Drainage Planning Conditions

Subject: Arundel Street, Manchester

Ref: 071713/DPC Rev V02

This revision has been prepared to pick up four comments received from the LLFA in June 2022, following review of the original application. Changes in this revision are highlighted in RED.

071713- CUR-XX-00-DR-C-92500_ **P02 PROPOSED DRAINAGE LAYOUT**

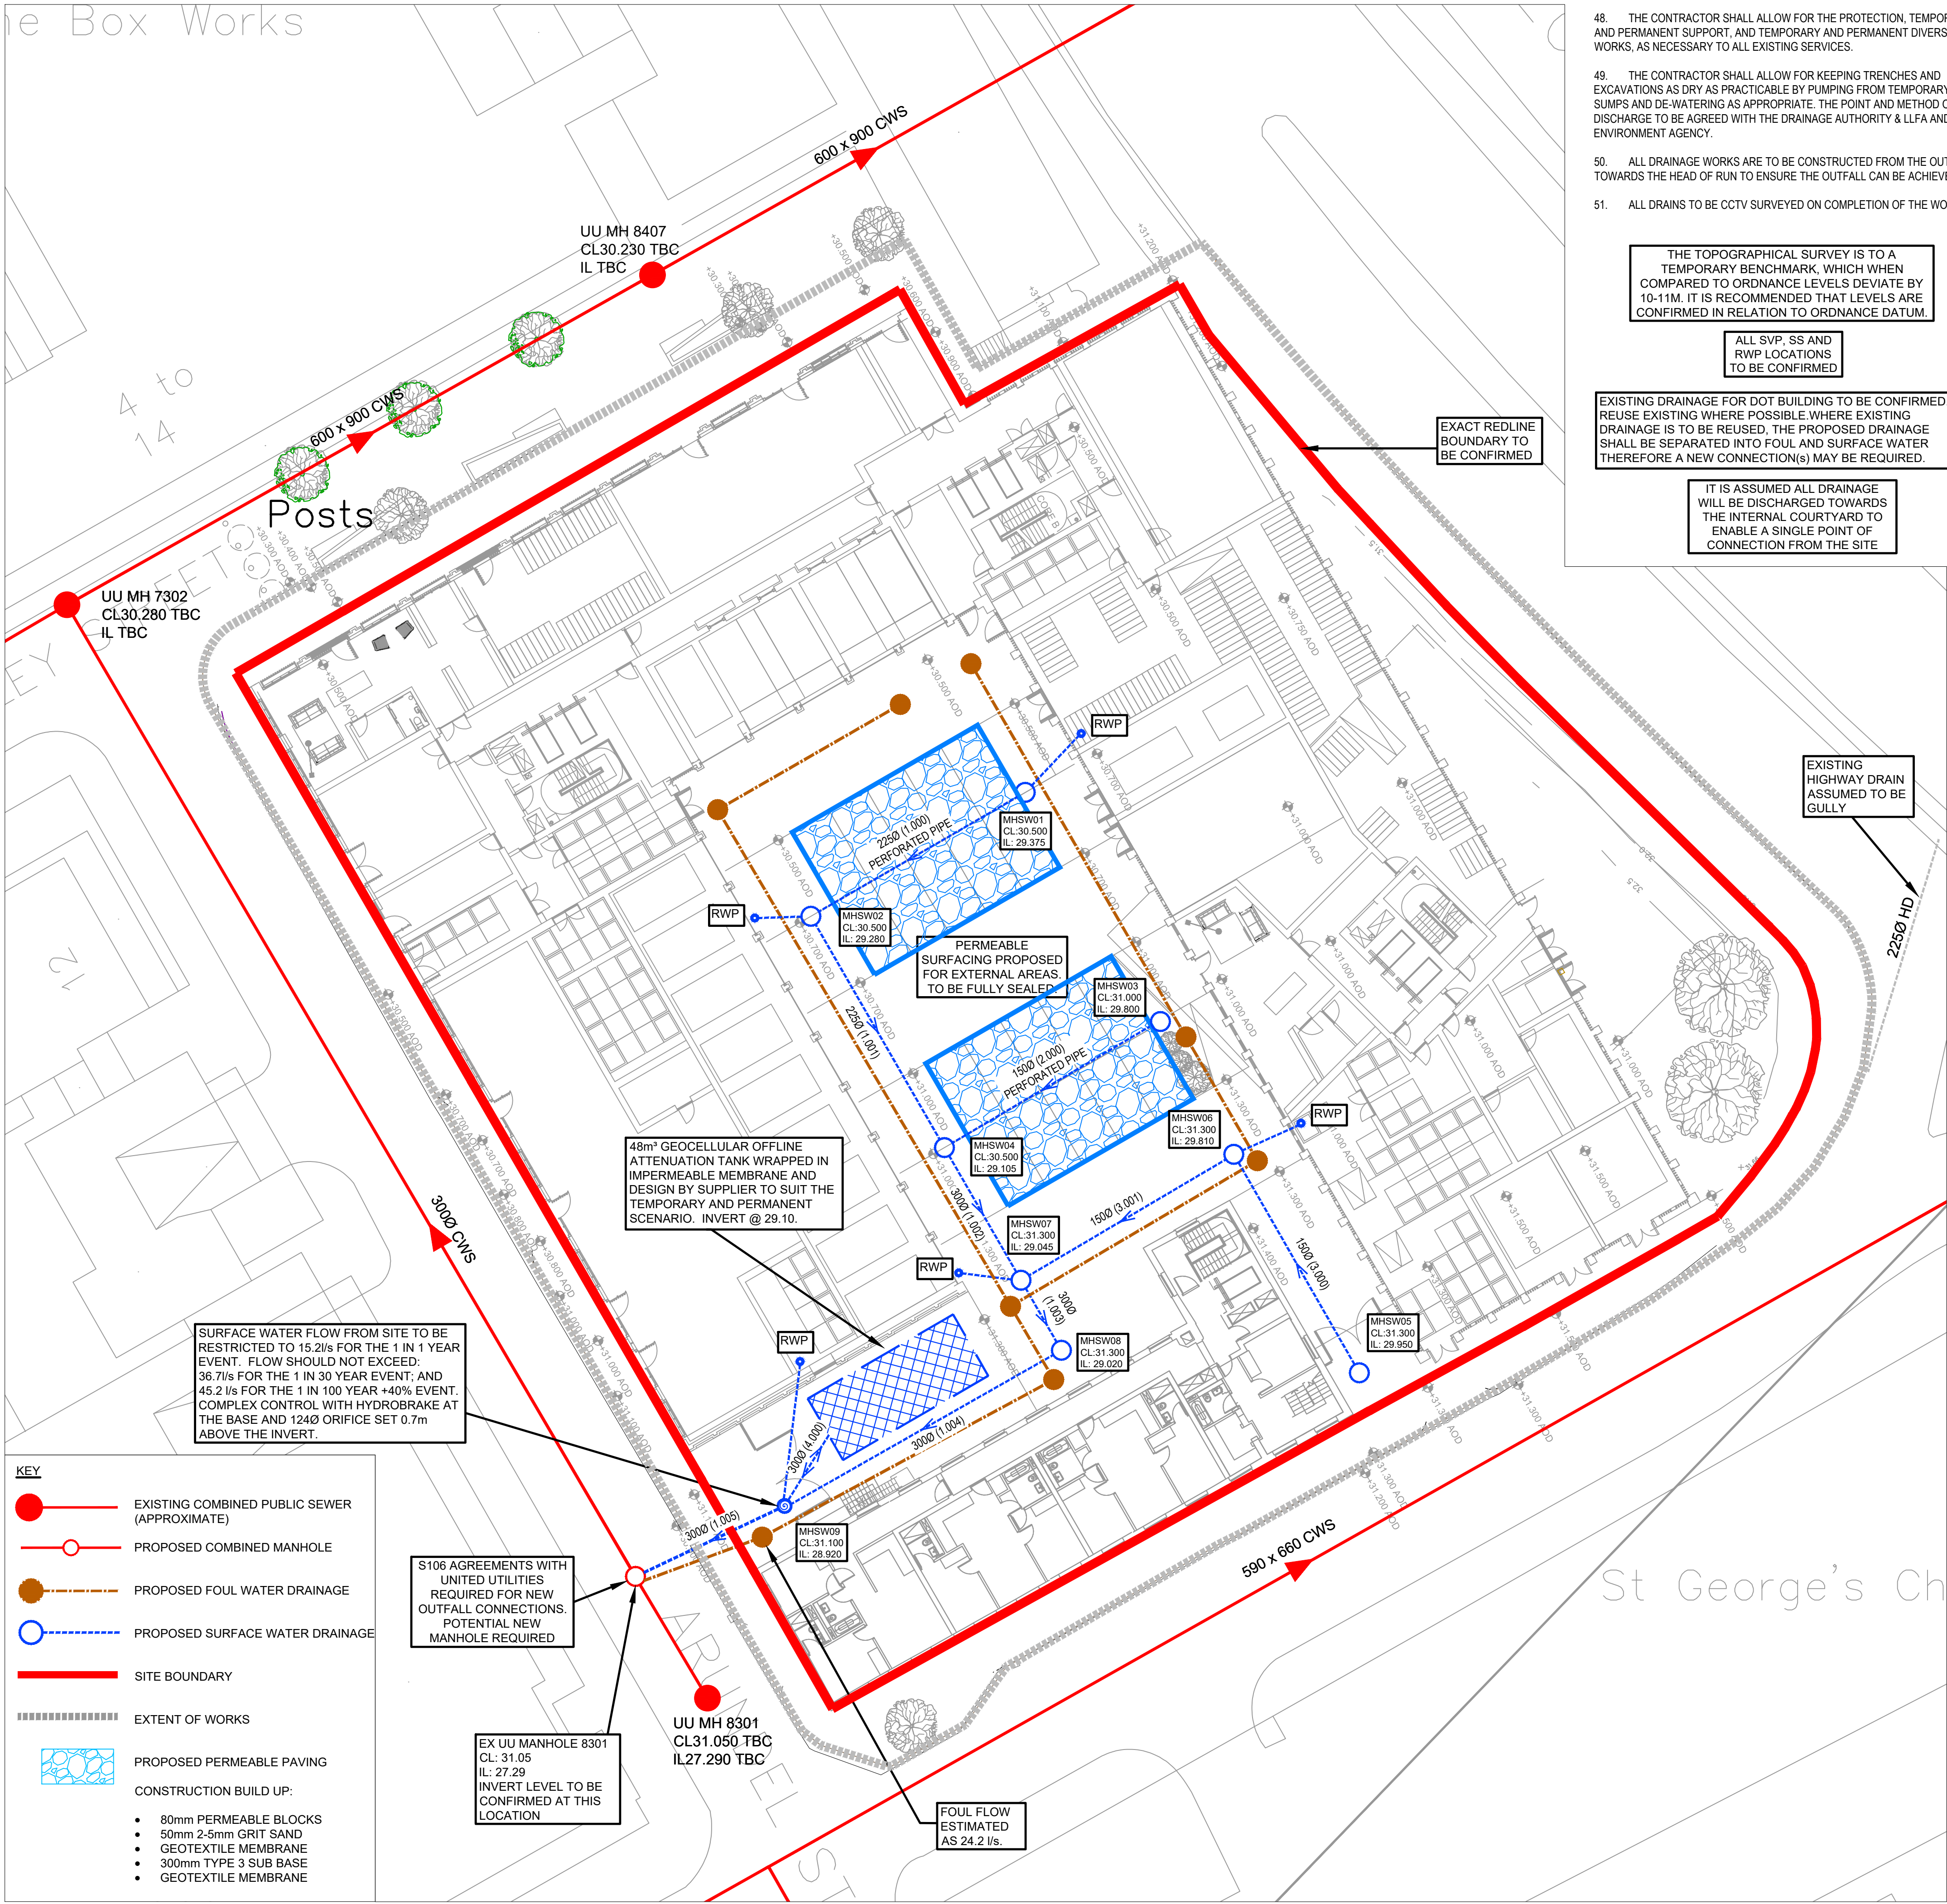
The flow rates currently modelled achieve the 1-year flow restriction of 15.25 l/s.

Use of SuDS has therefore been assessed and the current strategy proposes the use of permeable paving externally **within the parking bays**, which is currently assumed to consist of a 300mm stone layer providing 30% void for attenuation. The permeable paving is currently included in the drainage strategy model. **To further achieve the required attenuation volumes, a geocellular attenuation tank will also be incorporated into the design layout. The proposals also indicate that a roof garden is to be incorporated on building 1, and this would provide additional sustainable benefit. However, this element has not been included in the drainage calculations at this stage until final construction details are available. It is assumed for hydraulic modelling purposes that a worse case scenario of the green roof being fully saturated at the time of the peak storm, thus a full impermeable area has been allocated.**

Refer to drawing 071713- CUR-XX-00-DR-C-92500_ P02 PROPOSED DRAINAGE LAYOUT enclosed in Appendix A and Micro-Drainage Calculations: Proposed 1, 30 and 100 Year +40%cc events enclosed in Appendix B. **The modelling has identified 1.3m³ of exceedance flooding for the enhanced storm event. This will be retained in the low-lying permeable surfacing area in the centre of the car park and thus not impact on the proposed finish flood levels.**

P02	SW NETWORK UPDATED TO SUIT HYDRAULIC MODEL	11.07.22	OJT	CG
P01	UPDATED PROPOSALS FOR PLANNING	15.03.19	OJT	CG
Rev:	Description:	Date:	By:	Chk:

071713-CUR-XX-00-DR-C-92501_ P02 PROPOSED OVERLAND FLOW ROUTES

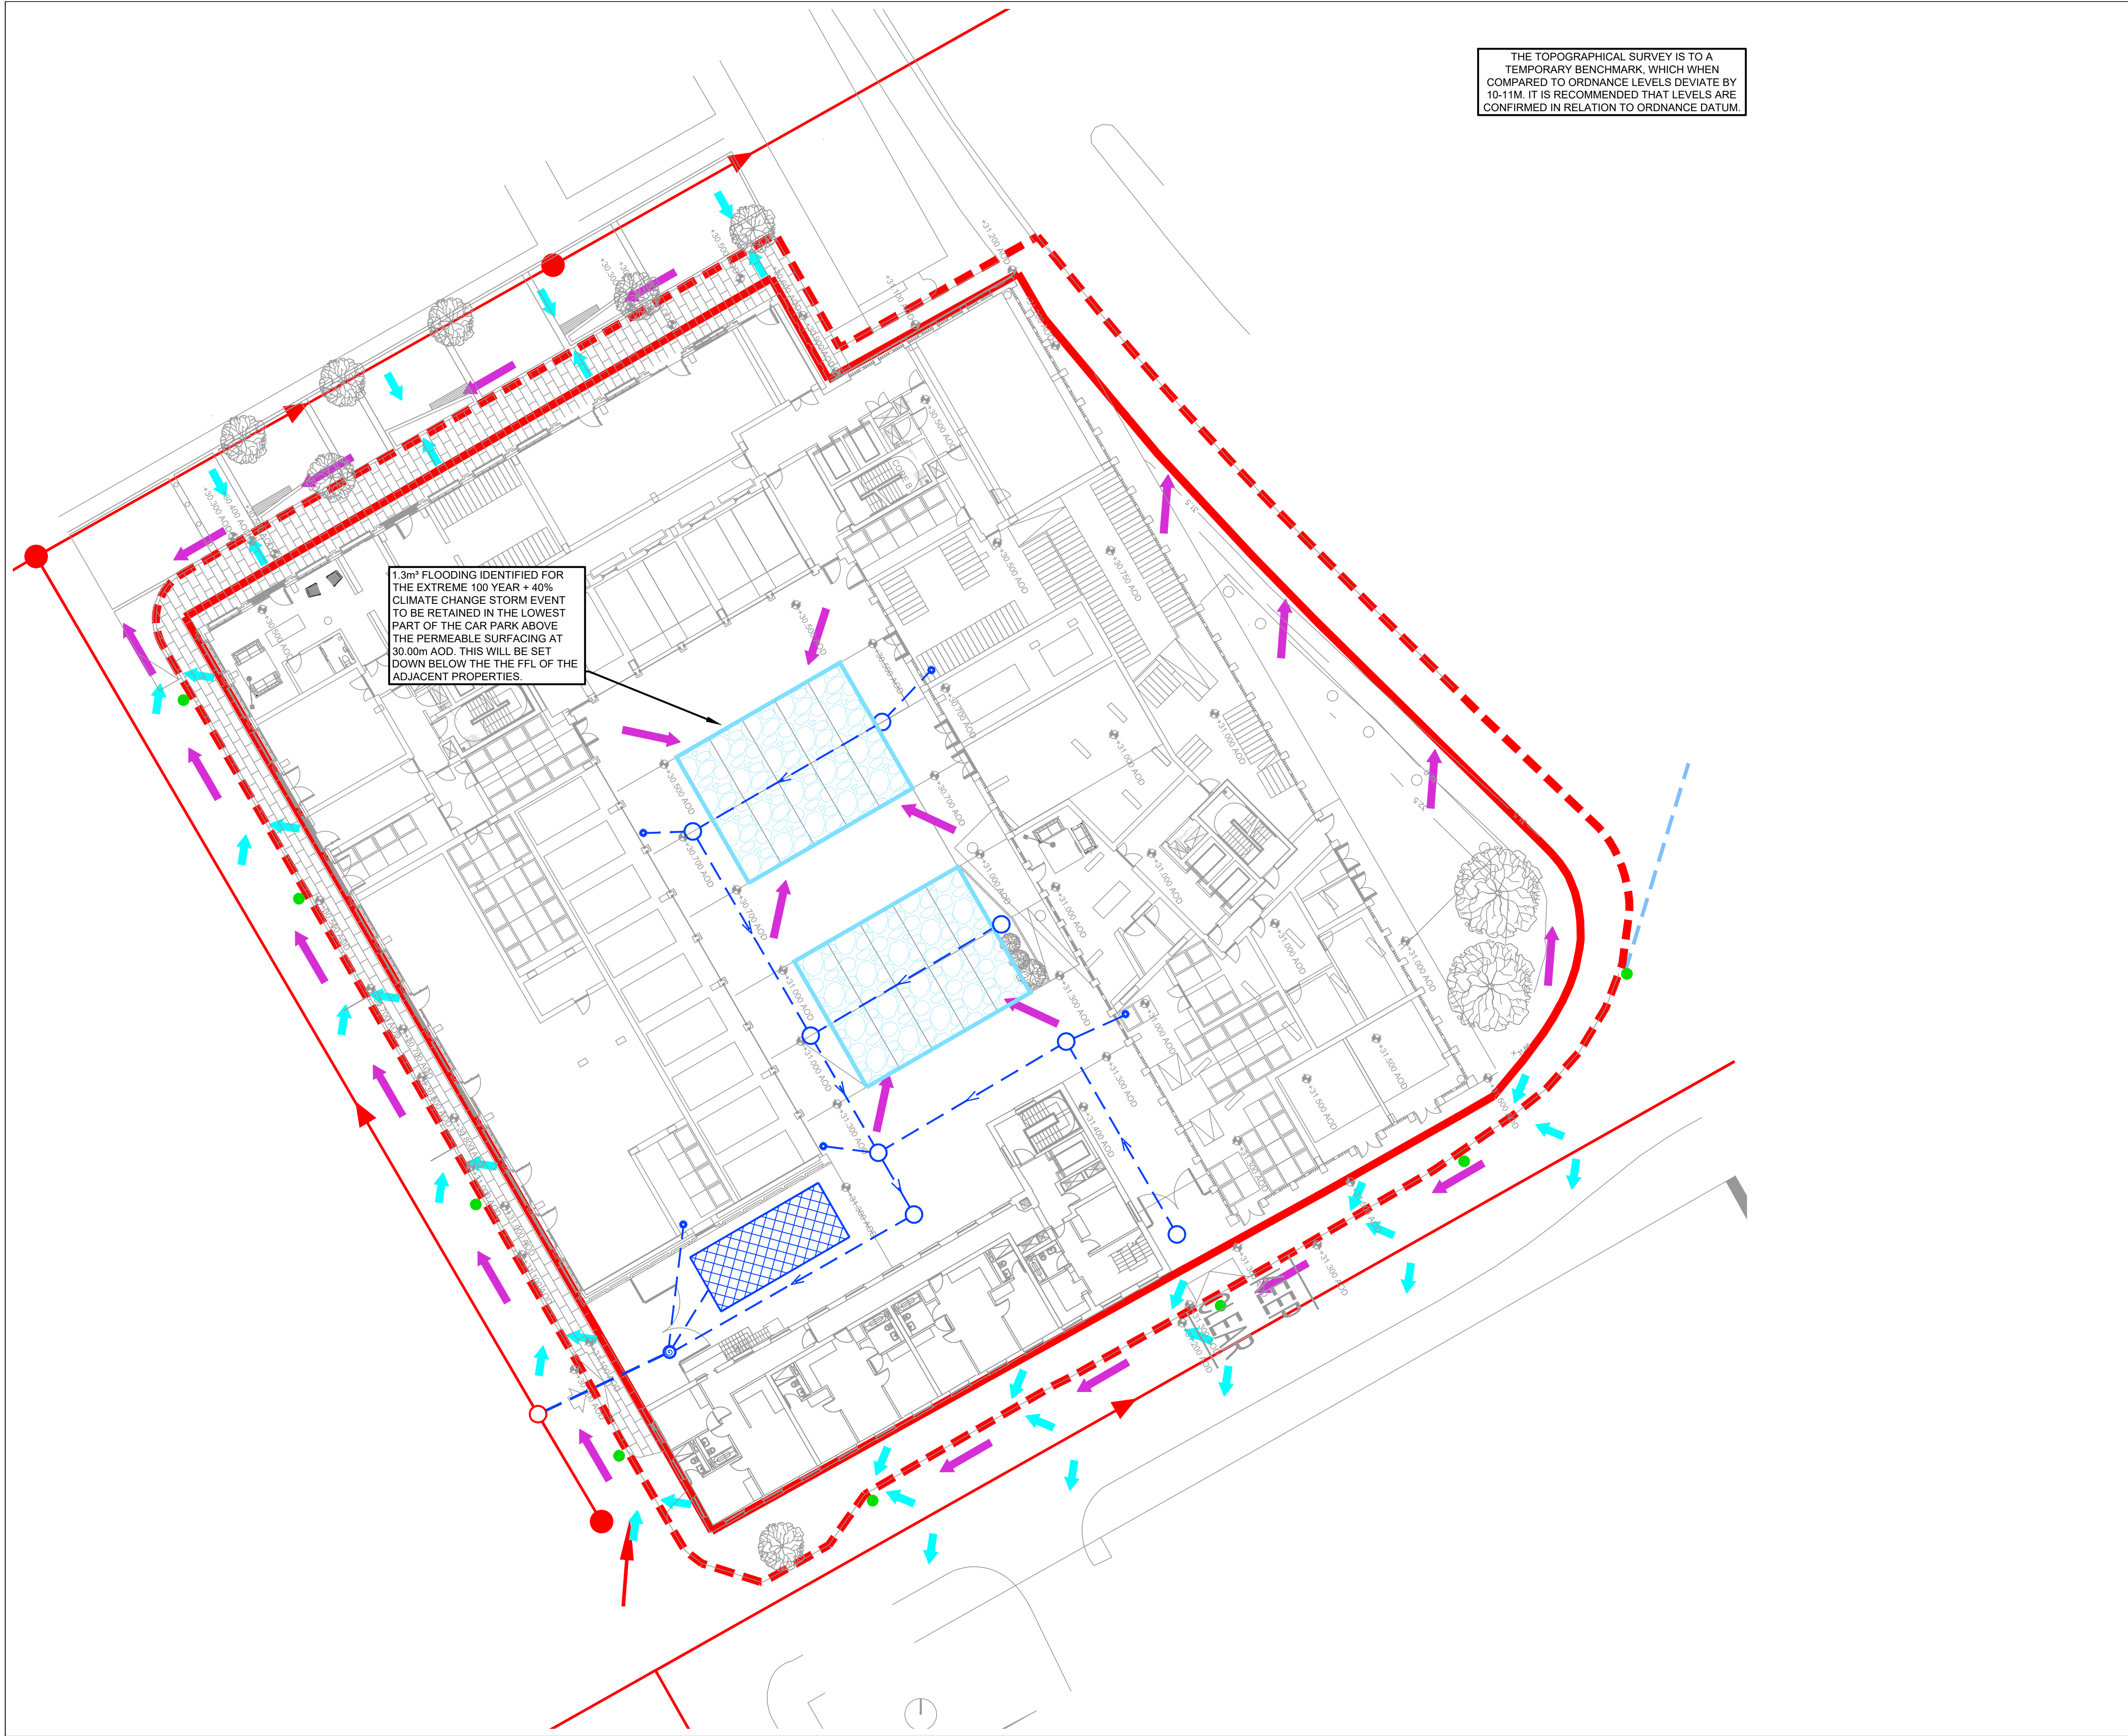
The modelling has identified 1.3m³ of exceedance flooding for the enhanced storm event. This will be retained in the low-lying permeable surfacing area in the centre of the car park and thus not impact on the proposed finish flood levels.

1.3m³ FLOODING IDENTIFIED FOR
THE EXTREME 100 YEAR + 40%
CLIMATE CHANGE STORM EVENT
TO BE RETAINED IN THE LOWEST
PART OF THE CAR PARK ABOVE
THE PERMEABLE SURFACING AT
30.00m AOD. THIS WILL BE SET
DOWN BELOW THE THE FFL OF THE
ADJACENT PROPERTIES.
